# TOWN OF PLAINFIELD DESIGN REVIEW COMMITTEE

**DATE:** 01-06-2026  
**CASE NO.:** DP-25-097  
**Project Page:** [Zaxby's Main at Smith](#)  
**PETITIONER:** Jessica Hood, Carter Engineering on behalf of Zaxby's  
**REQUESTED ACTIONS:** Architectural and Site Design Review for a proposed drive-thru restaurant of approximately 2,300 square feet in size.  
**LOCATION:** 2560 East Main Street  
**PARCEL SIZE:** .965 acres +/-

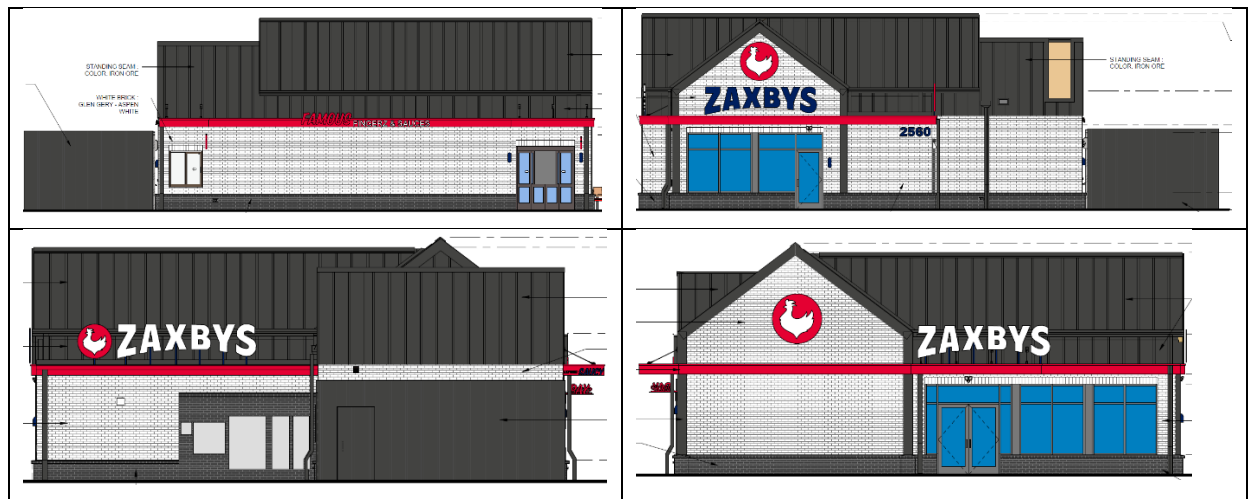
Review Area	Code Reference	Status	Questions / Comments		
<b>Building Design</b>					
Minimum Yards and Building Setbacks	14.2.E.2	Complies	Setback Side	Required	Shown
			Front	20'	20'
			Side (L)	5'	5'
			Side (R)	20'	20'
			Rear	20' Buffer	20'
Maximum Building Height	14.2.E.2	Complies			
Building Materials	5.5.C.3.2	Complies	Façade Points	Required	Shown
			North	600	609.7
			East	600	606.65
			South	600	653.9
West	600	645.32			
Mechanical Equipment:	5.5.C.4.d, 4.1G	Complies			
Building Lighting	4.9.C	Complies			
<b>Site Design</b>					
Drive-Through Facilities	4.1.D	Complies			
Loading Space Orientation	5.5.C.4.b	Complies			
Outside Storage	5.5.C.4.c	N/A			
Outdoor Seating/Dining	4.16.E	Complies			
Parking Area Location	4.10.C	Complies			
Off-Street Parking Area Cross Access Connection	4.10.D.7	Needs Attention	The 15' drive lane pictured below does not appear to be in compliance with the PZO

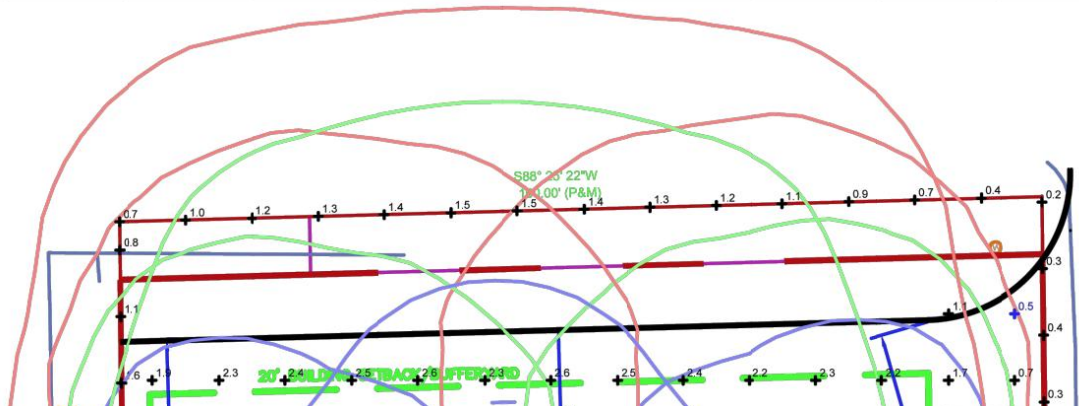
- 1) Three signs (West & East Zaxbys – Raceway Signs, Famous Fingerz & Sauces – Awning Sign) will need approval from the Plan Commission as they are not sign types typically permitted for new construction projects under the zoning ordinance. PC is empowered to approve alternative sign types only.
- 2) The applicant will have to apply for two (2) separate sign permits for the Zaxbys & Logo sign on the South elevation. This is due to the size of the sign measured as a single sign versus two separate.
